CLIENT: METRO PROPERTY DEVELOPMENT  
PROJECT: CENTRAL VILLAGE STAGE 4 AND 5  
ADDRESS: CORNER OF WATER AND BRUNSWICK STREET

DRAWING TITLE  
SITE PLAN EXISTING/DEMOLITION

PLANS AND DOCUMENTS  
referred to in the PDA APPROVAL

| DRAWING TITLE                                             |          |             |       |
|-----------------------------------------------------------|----------|-------------|-------|
| KEY PLAN - LEVEL 14-20 (Stage 5)<br>Level 12-28 (Stage 4) |          |             |       |

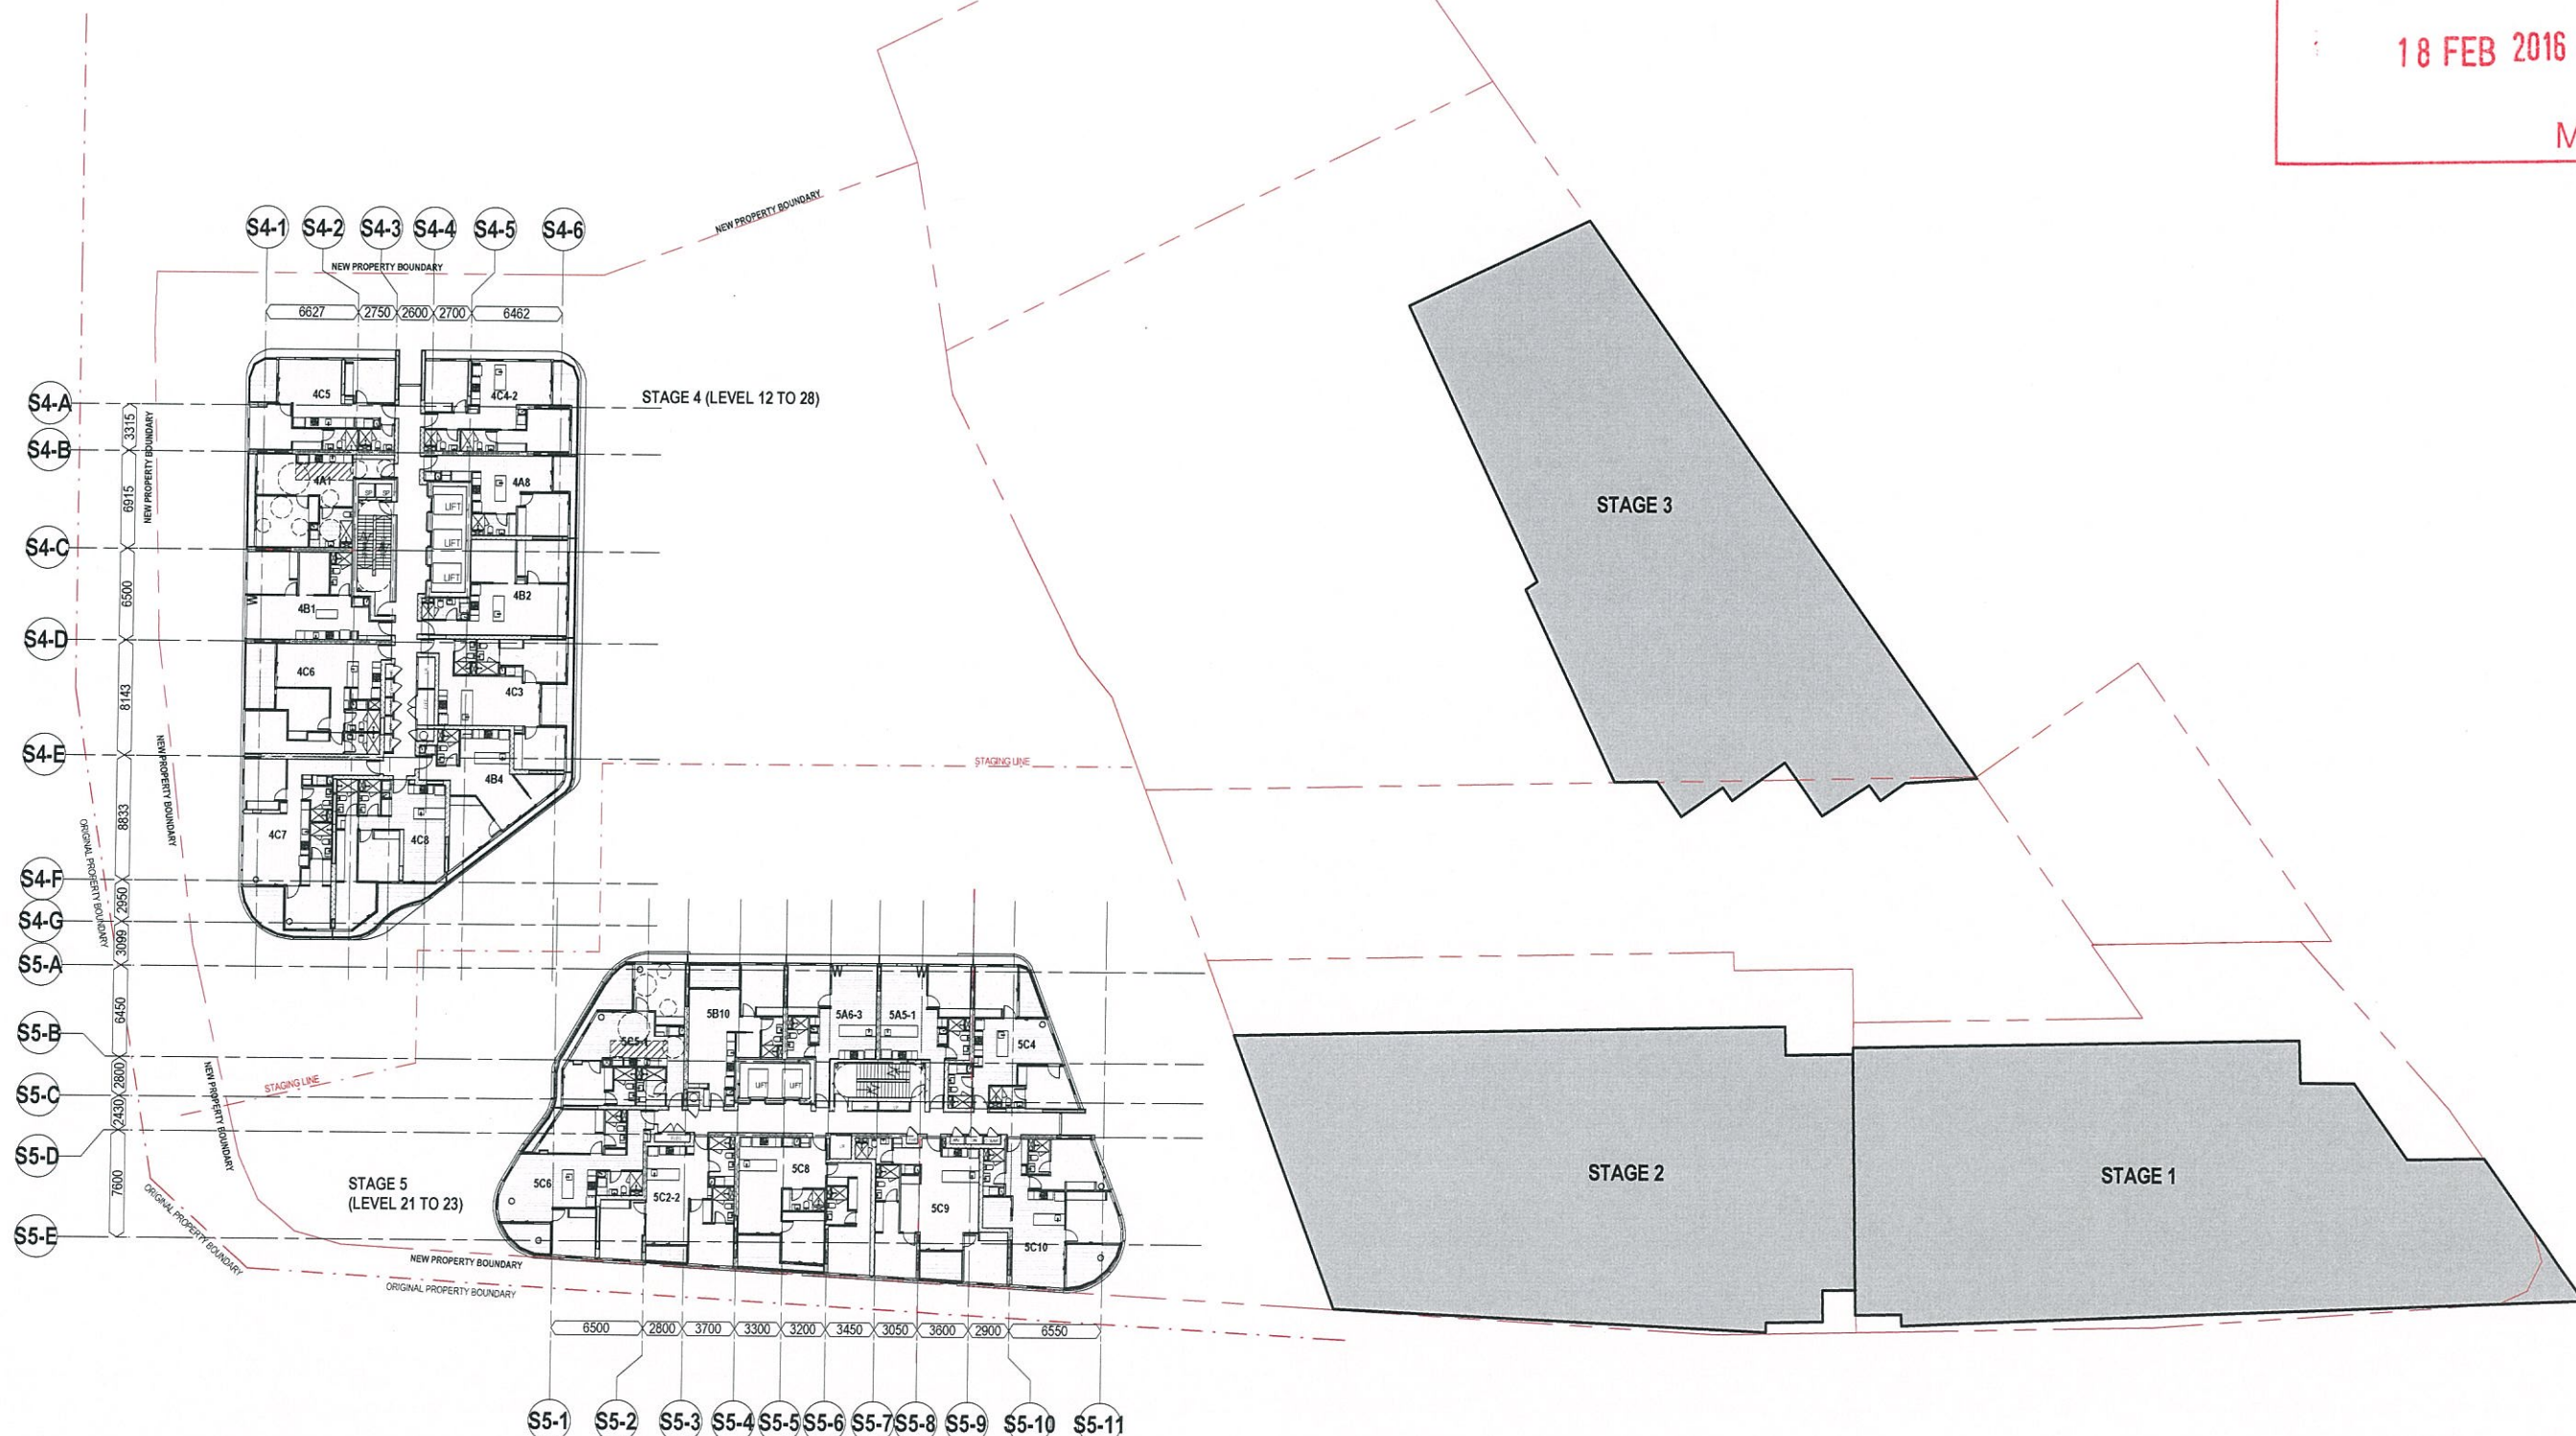
AMENDED IN RED
